Access Compliance Report

Public Rights-of-Way

(Curb Ramps)

Intersection ID: 10025870	Main Street: ELEVATION_POINT_DR	Cross Street: N/A	Location: SE
ADA ID: B69A14DC0242	Ramp Type: Perp	Initial Pass/Fail: Fail	Overall Compliance: No
Codes/Mitigation Info/Possible Solution		Field Measurements/Component Compliance	
Severity Score: 13.75

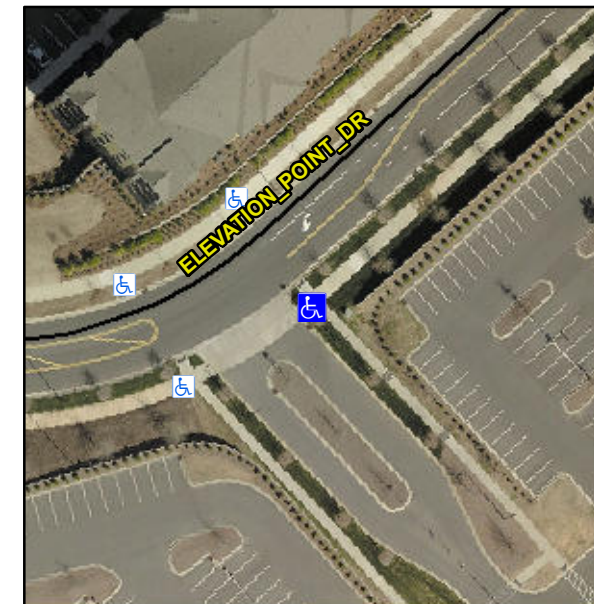
Not Found, R304.2.2

Compliance	Description	Data	Compliance	Description	Data
N/A	Ramp Length (in)	96.0	No	Ramp Slope (%)	8.5
Yes	Ramp Width (in)	56.0	Yes	Ramp XSlope (%)	2.1
N/A	Flare Type LT	N/A	N/A	Flare Type RT	N/A
N/A	Flare Slope LT (%)	N/A	N/A	Flare Slope RT (%)	N/A
N/A	Flare Traversable LT?	N/A	N/A	Flare Traversable RT?	N/A
N/A	Landing Length (in)	N/A	N/A	DWS Provided?	N/A
N/A	Landing Width (in)	N/A	N/A	DWS Contrast?	N/A
N/A	Landing Slope (%)	N/A	N/A	DWS Length (in)	N/A
N/A	Landing X Slope (%)	N/A	N/A	DWS Full Width?	N/A
N/A	Landing Curb? (Y/N)	N/A	N/A	DWS Offset (in)	N/A
N/A	Shared Landing?	N/A			
N/A	Gutter Ponding?	N/A	N/A	Gutter Slope (%)	N/A
N/A	Gutter Lip Ht (in)	N/A	N/A	Gutter X Slope (%)	N/A
N/A	Painted X Walk1?	No	N/A	Painted X Walk2?	N/A
	X Walk 1 Direction	To NW		X Walk 2 Direction	N/A
N/A	X Walk 1 Width (in)	N/A	N/A	X Walk 2 Width (in)	N/A
	X Walk 1 Slope (%)	1.3		X Walk 2 Slope (%)	N/A
	X Walk 1 X Slope (%)	3.5		X Walk 2 X Slope (%)	N/A

Remove & Replace Entire Ramp.
